STAGE 1 & 2 ROAD SAFETY AUDIT

SECTION 278 ACCESS WORKS, FIELD HEAD LANE, BIRSTALL

Job No: 26019

March 2026

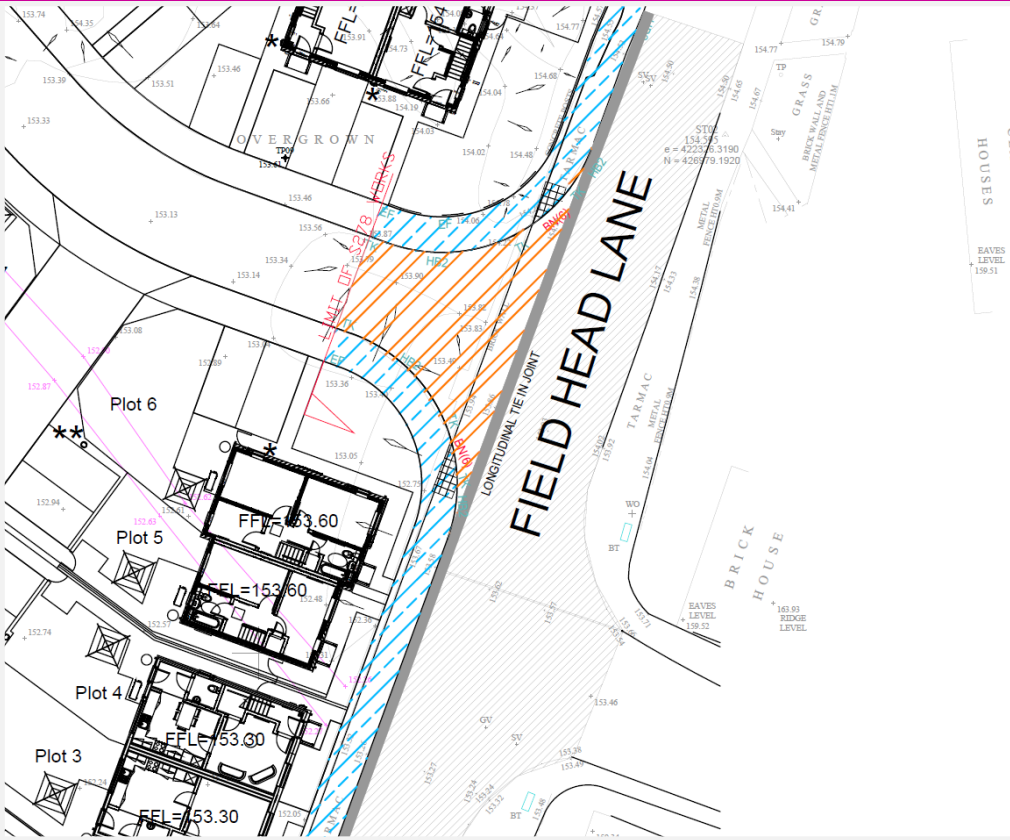
Problem 1	
Location	Site access off Field Head Lane.
Summary	It is not clear if the tracking analysis demonstrates that there is sufficient carriageway available at the junction.
<p>It is not clear if there will be sufficient carriageway available to accommodate vehicle turning movements at the junction, particularly for large vehicles, if vehicles are parked directly opposite the junction on the east side of Field Head Lane. This will result in vehicles riding onto the footpaths and at risk of conflicting with pedestrians.</p>	
Recommendation	
<p>It is recommended that the designers ensure that there is sufficient carriageway and or waiting restrictions (yellow lines) provided at the junction to the site, to accommodate all vehicle turning movements on and off Field Head Lane, particularly when vehicles are parked on the east side of Field Head Lane.</p>

DART have undertaken tracking as shown on drawing 25469-DR-C-0136 P2 S278 Vehicle Swept Path Tracking
